NOTICE OF DECISION

DECISION OF THE PLANNING ADMINISTRATOR

CLASS 3 SITE PLAN REVIEW / CLASS 2 ADJUSTMENT / CLASS 1 DESIGN REVIEW CASE NO.: SPR-ADJ-DR22-13

SUMMARY: A proposal for renovations to Hallman Elementary school including development of a new vehicle use area.

SHEET NO:
C-0.4
OF 26

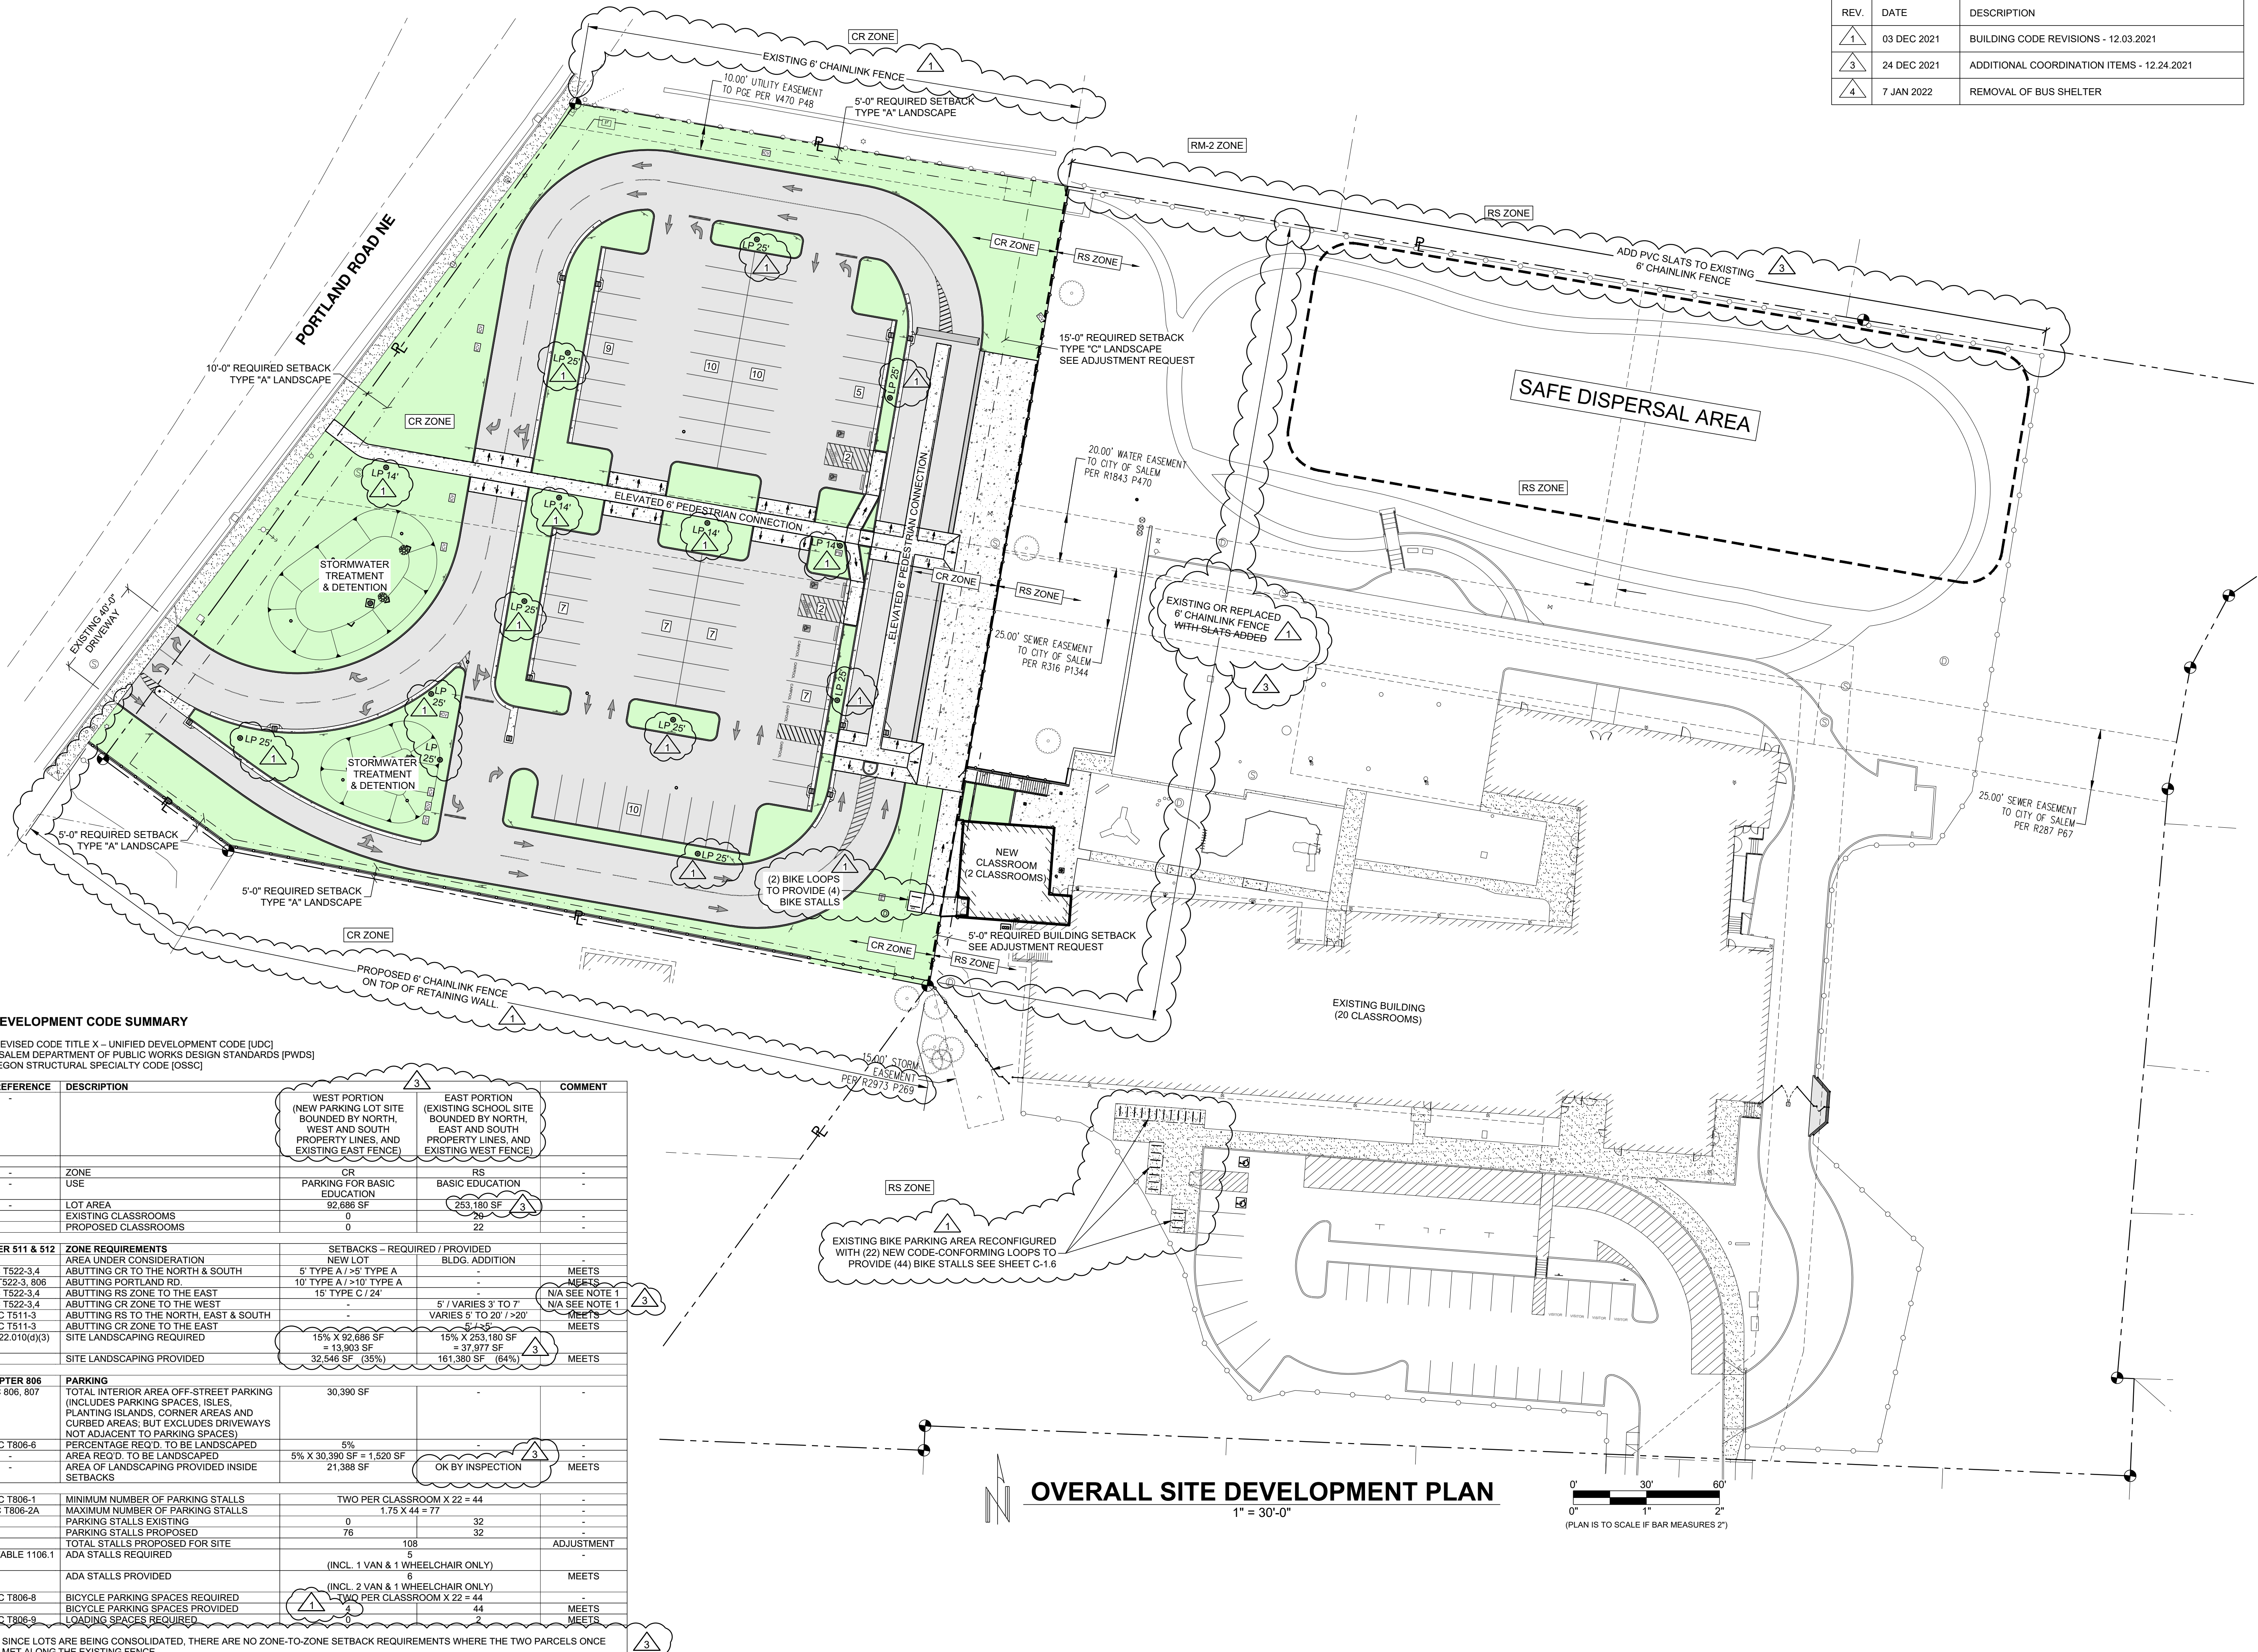
Finding: There are two new classrooms being proposed within the RS section of the property. The new classrooms are approximately twenty-two feet in height, requiring a twenty-two-foot setback. The applicant has provided a site plan showing that the new structure is approximately thirty feet from the closest southern property line and two and

North: The CR portion of the property is adjacent to commercially zoned property on the north, requiring a minimum of five feet setback. The site plan demonstrates a minimum of five feet between the property line and the proposed vehicle use area.

Finding: The applicant has provided a site plan showing a pedestrian connection through the parking area from the public sidewalk to the main building entrance. It is shown as six feet in width and is visually differentiated and raised above the parking area per the project enhancements below. There are no areas where the proposed parking spaces will encroach onto the pedestrian pathway. This standard is met.

Finding: The applicant has chosen Method A to separate vehicle use areas from the abutting Portland Rd NE, showing ten feet of Type A landscaping. Adjacent to interior lot lines, the applicant has provided five feet of Type A landscaped setback, pursuant to this section and the zoning standard of the CR Zone. The southern parking area is not being modified with this application. This standard is met.

DECISION: The **Planning Administrator APPROVED** Class 3 Site Plan Review / Class 2 Adjustment / Class 1 Design Review Case No. SPR-ADJ-DR22-13 subject to the following conditions of approval:

Condition 1: The applicant shall consolidate 4000 Deerhaven Dr NE and 4130 Portland Rd NE, (Marion Co Tax Lot Nos. 073W12AC/3201 and 073W12AC/3200) prior to final occupancy.

| SHEET NO: | C-1.2 |

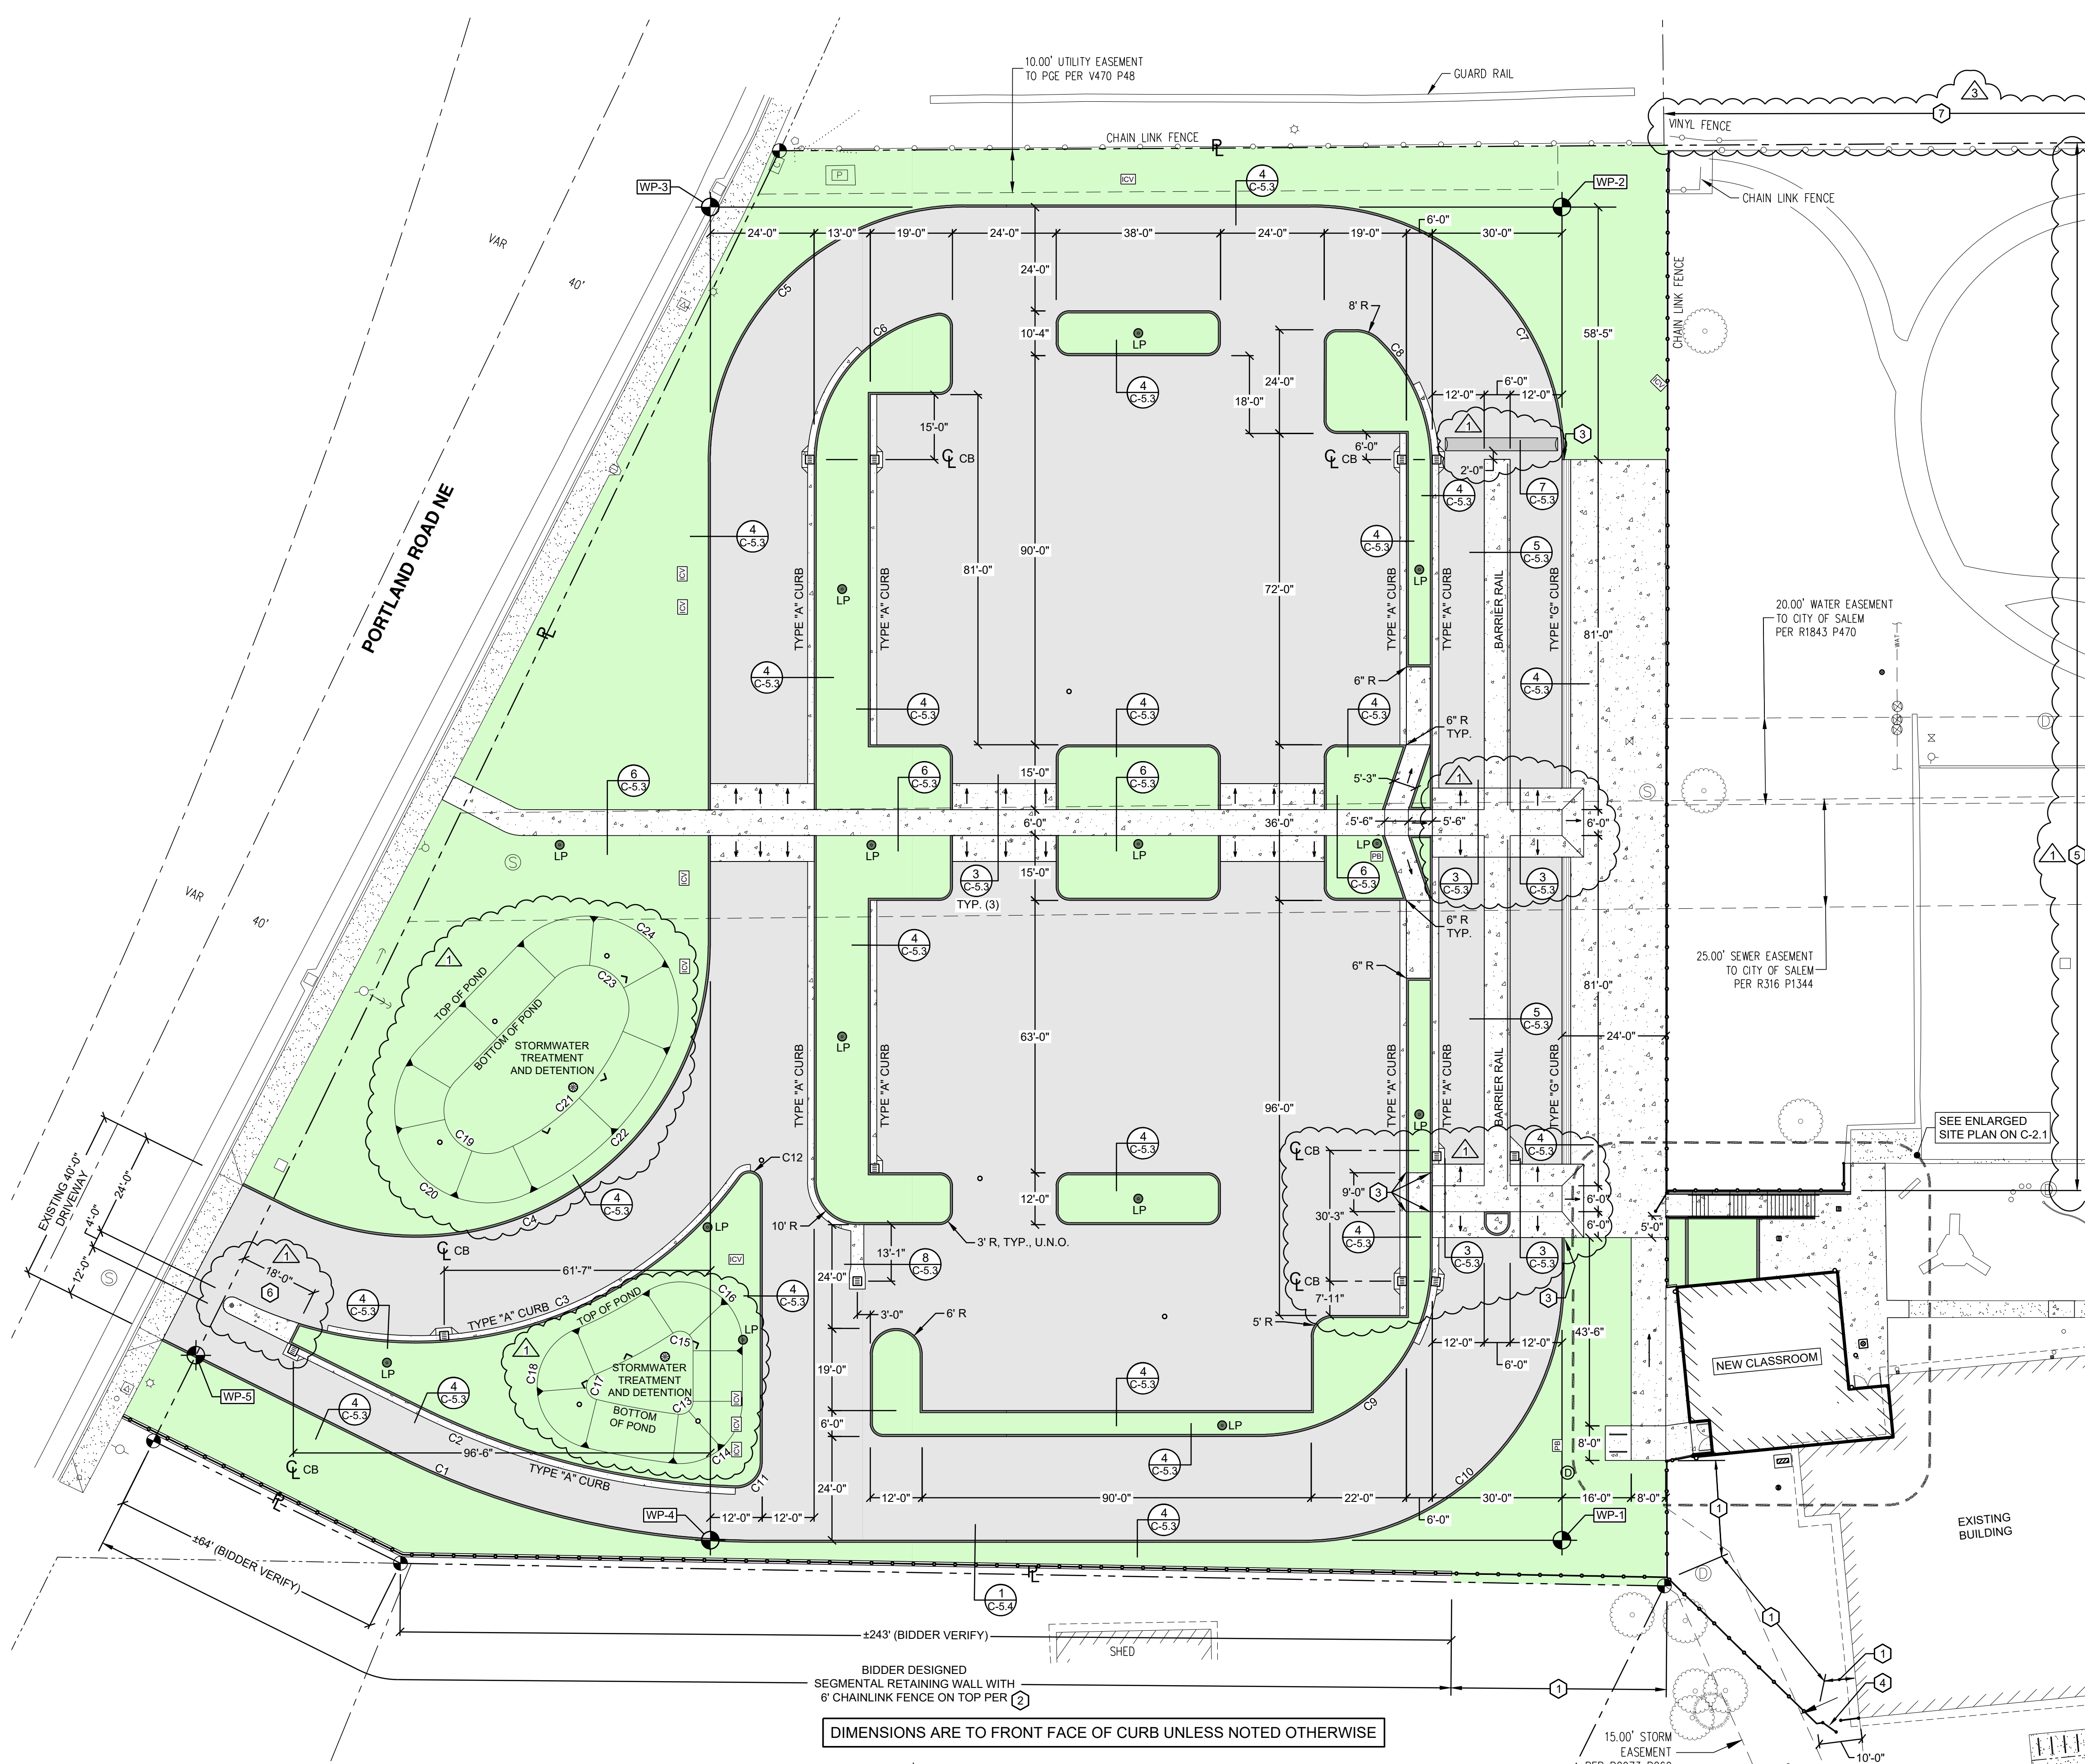
Finding: The applicant has provided a site plan showing no parking located within setbacks. The carpool spaces, though not required, are located close to the newly proposed entrance. There is no underground parking proposed. This standard is met.

Finding: The applicant has provided a site plan with two areas for bike parking spaces. The newly proposed bike parking spaces located on the western side of the site are located within fifty feet of the main entrance on that side of the building. On the southern side of the site, there is an existing bicycle parking area that is located approximately 150 feet away from the southern main entrance. The applicant has requested an adjustment to this standard and the findings are addressed in the adjustment section below.
